SUBJECT: Racing Modifications

1973 SET-UP PROCEDURE FOR BRUT SNOWMOBILE

Bulletin No. 101Date 10-25-72

service bulletin

1. ENGINE MODIFICATION SPECS FOR SUMMER GRASS RACING

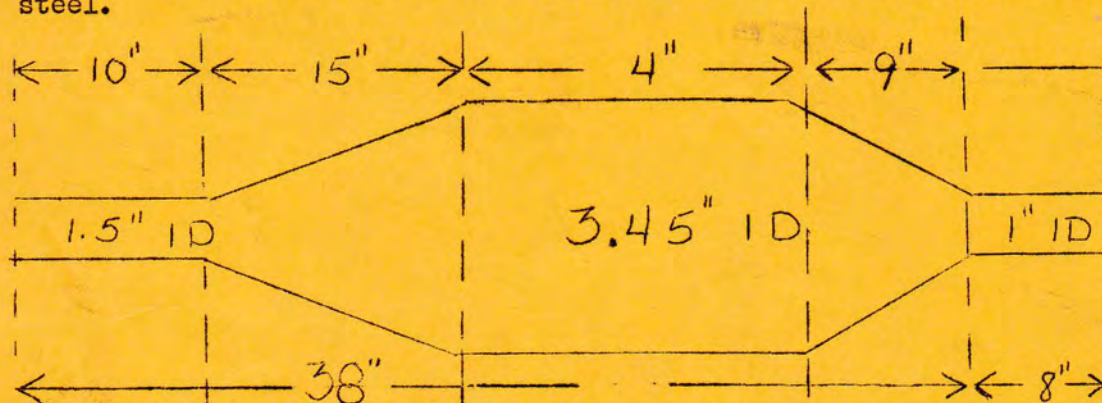
Ports All ports will be measured from the top of the cylinder.

Exhaust Port 29.5 mm

Intake Port 89.5 mm

Radius all edges with file & cloth. Do NOT widen ports.
